ANN ARBOR PLANNING DEPARTMENT STAFF REPORT

For Planning Commission Meeting of September 19, 2017

**SUBJECT: Weber Site Plan (2857 Packard Road)
File No. SP17-004**

SUBJECT: **Site Plan:** 2857 Packard
Location: 2857 Packard
Plans Dated: July 14, 2017
Project Number: SP 17-004

2857 PACKARD ROAD
SITE PLAN
SITE LAYOUT PLAN

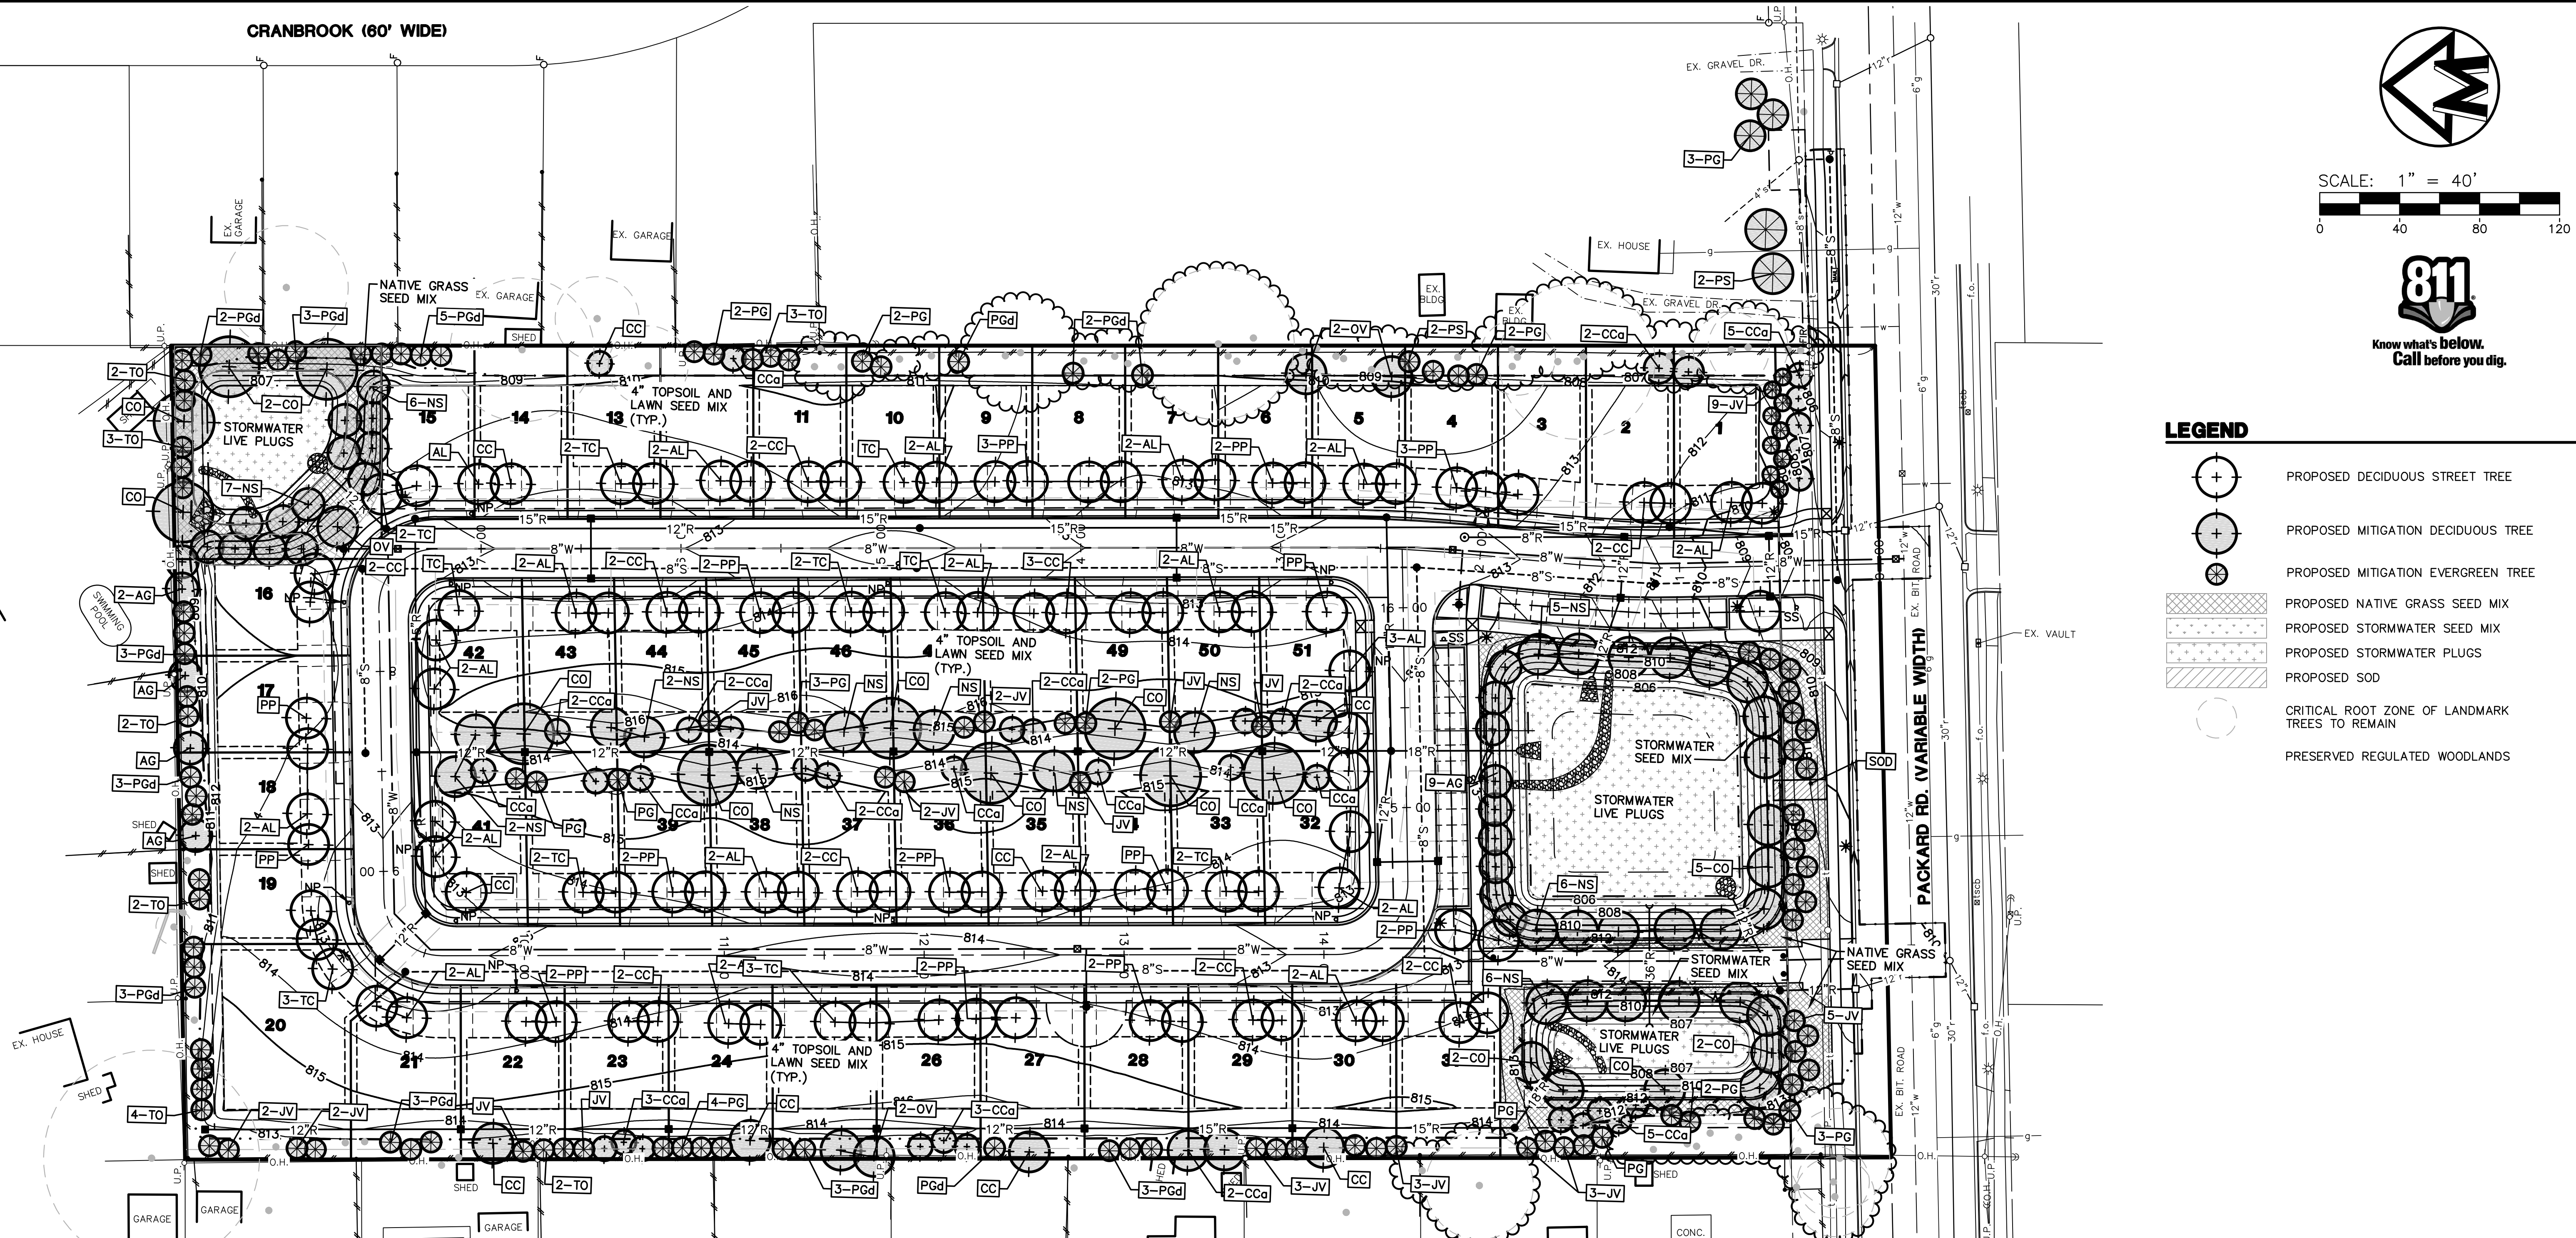
Staff recommends that this site plan be **denied** because the development does not limit the disturbance of natural features to the minimum necessary to allow a reasonable use of the land applying the criteria for reviewing a natural features statement of impact as provided in City Code. Also, the site plan does not comply with the City Master Plan recommendation of protecting existing natural features.

As stated in the Urban Forester's attached comments there is a significant stand of Bur Oak trees on the west side of the property that include trees of the following sizes measured in DBH inches (DBH= diameter measured at 4.5 feet above the ground): 60", 41", 37", 35", 30", 25" and 20". This area contains several trees dating back to pre-settlement Ann Arbor and represents a native forest fragment, which is considered the highest priority for protection. The proposed plan removes this stand of Bur Oak trees and the other smaller woodland trees around it.

The site also contains woodlands in the middle of the site classified of as mid-level concern for protection. These urban woodlands are comprised of a mixture of landmark and woodland Black walnut and Honeylocust trees. The proposed plan removes these woodlands.

This area with several trees dating back to pre-settlement Ann Arbor represent a native forest fragment which is considered the highest priority for protection. The proposed plan removes this stand of Bur Oak trees and the other smaller woodland trees around it.

- ii. The site also contains woodlands in the middle of the site classified of as mid-level of concern for protection. These urban woodlands are comprised of a mixture of landmark and woodland Black walnut and Honeylocust trees. The proposed plan removes these woodlands.
 - iii. Tree canopy provides important environmental and ecological functions to the community, including improving the quality and quantity of stormwater run-off; improving air quality; reducing energy usage; providing wildlife habitat and ameliorating summer temperatures. The Mallet's Creek creekshed, which includes this site, has a tree canopy of 28% (based on a 2010 city-wide tree canopy study), which is below the City average of 33% tree canopy cover. More specifically this site and the surrounding neighborhoods have an average tree canopy cover of 31%.

- d. The amount of disturbance in relation to the scale of the proposed development and to that permitted by Chapter 55 (Zoning).
 - i. This proposed site plan does not preserve any high or mid-level of concern woodland or landmark trees. The site plan proposes preservation of 7 landmark trees on the eastern property line with 5 of these trees having impacts into their critical root zone; a 19" Boxelder with a health and condition score of 14 out of 30 is one of the trees to be preserved. The petitioner did not consider the quality of natural features that they chose to preserve on the site (see chart and site plan).

Staff has requested that the Petitioner alter lot sizes and building envelopes to preserve some of the high and mid-quality natural features on the site. Alternative site layouts provided by the Petitioner demonstrate layouts that better accomplish this than the selected layout and are attached.

2857 PACKARD ROAD
 SITE PLAN
 LANDSCAPE PLAN

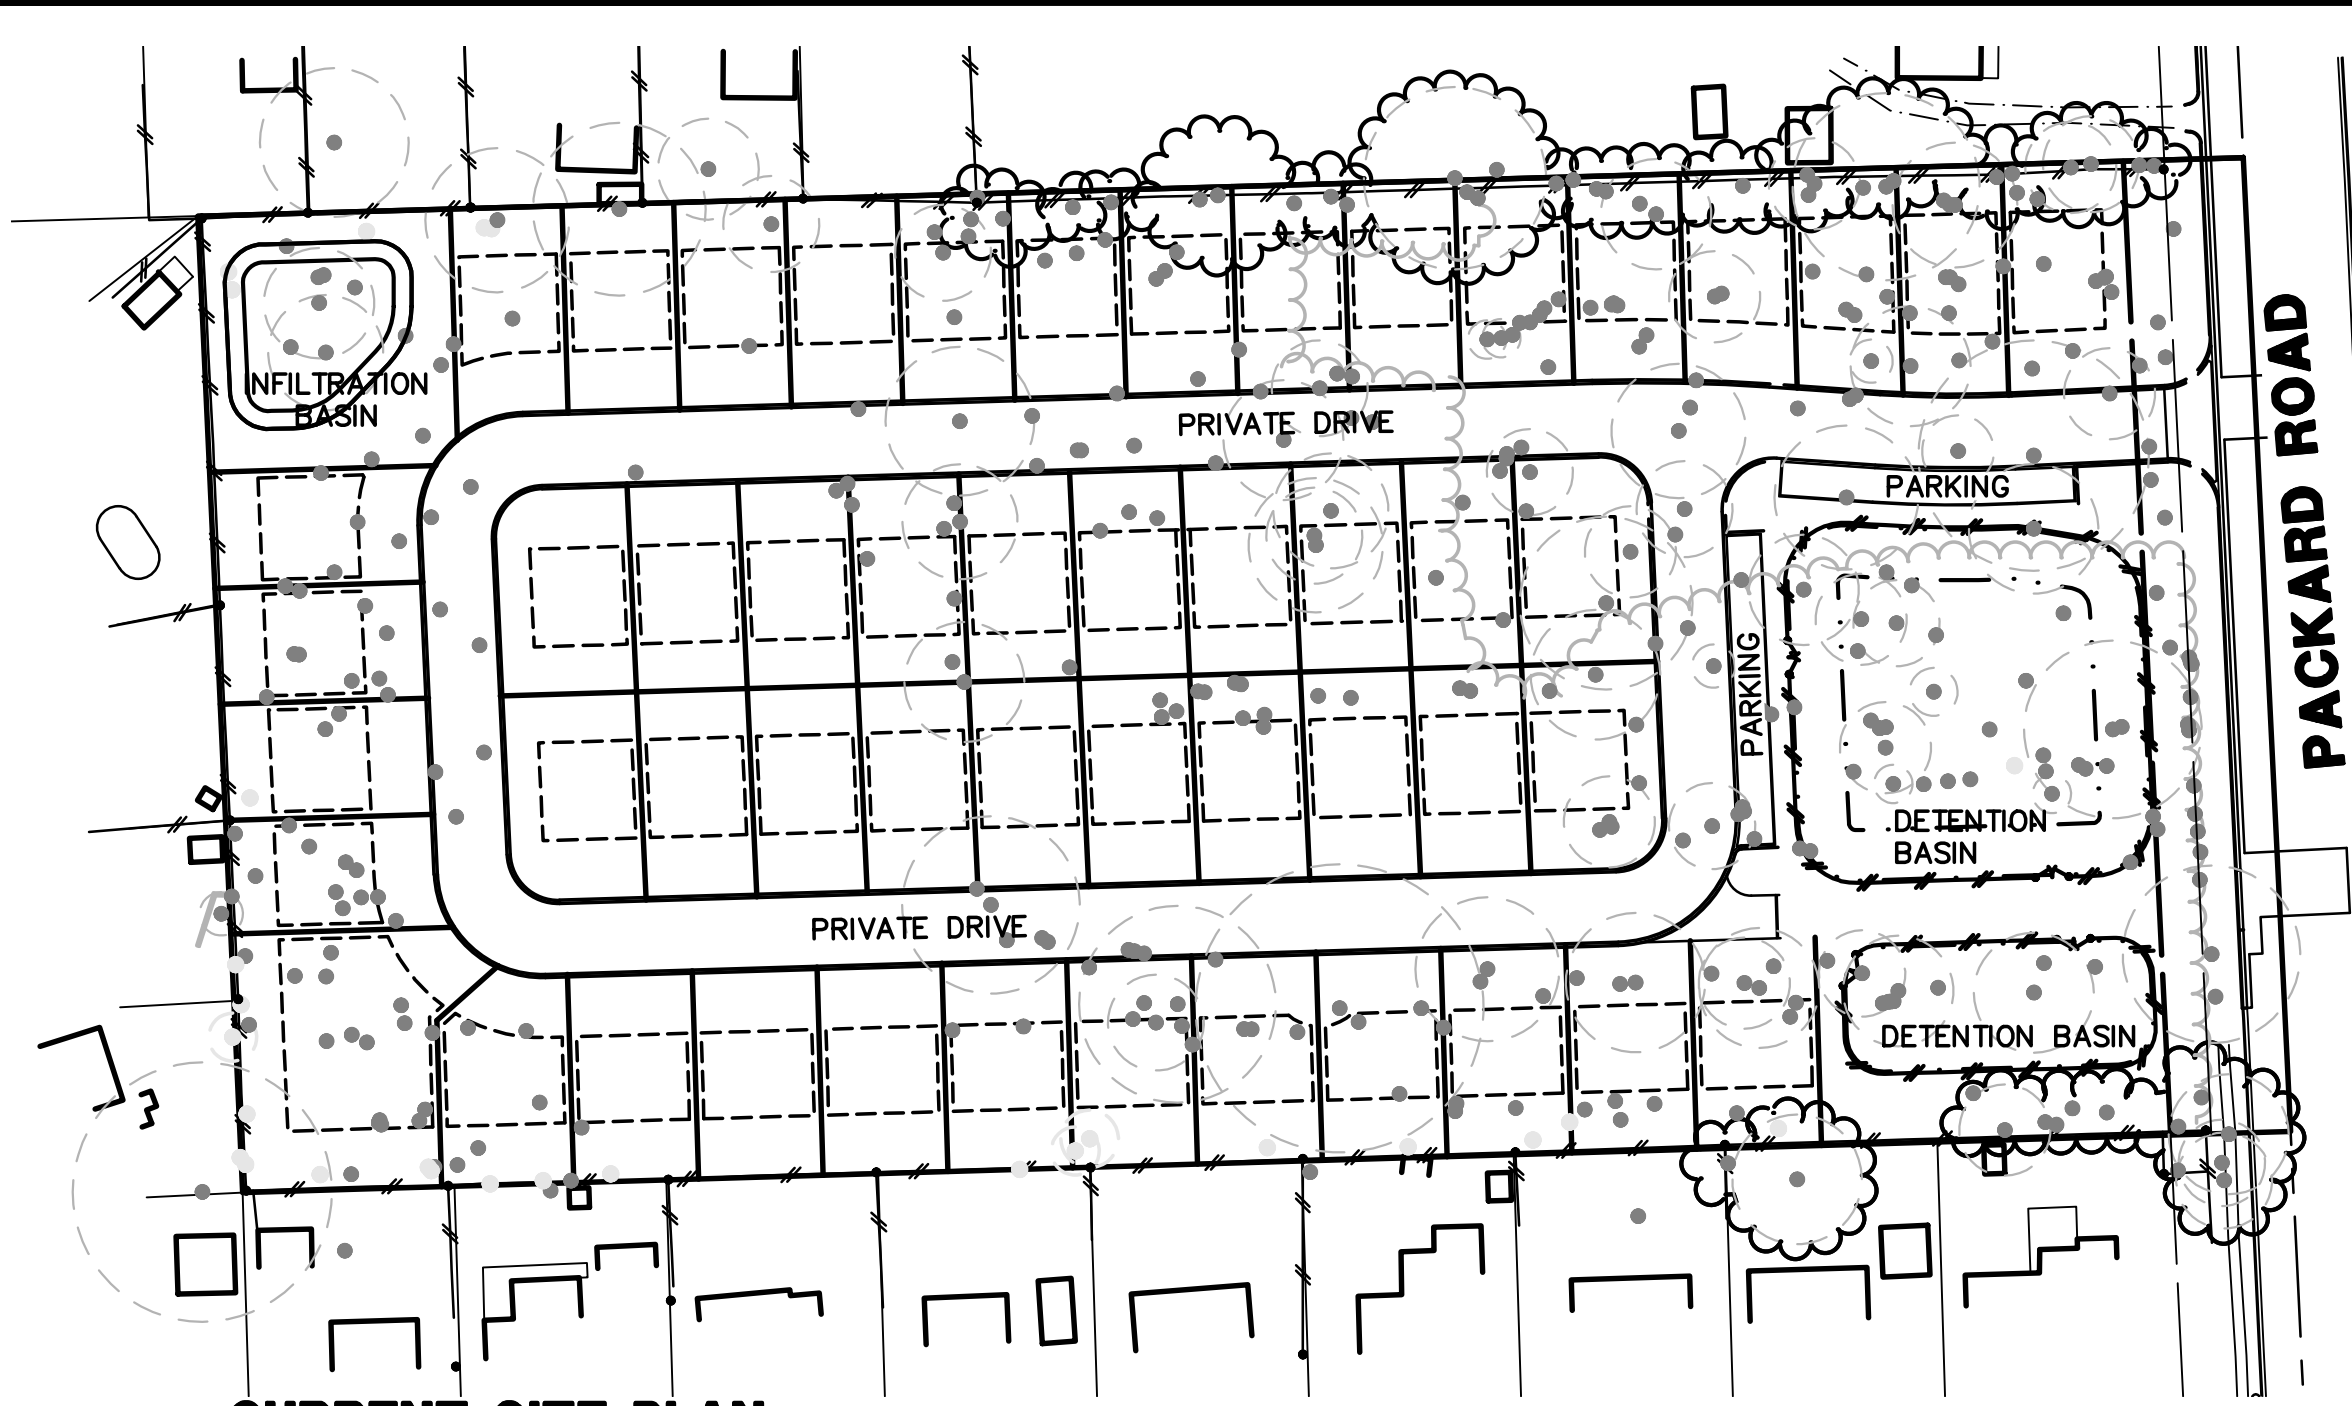
- e. The adequacy of the mitigation plan.
 - i. The petitioner provided all of the landmark and woodland tree mitigation in the Washtenaw County Water Resources Commissioners (WCWRC) easements.

- 2. The roots of the trees that are planted within the easement and near the stormwater management system may cause future maintenance issues to the system.
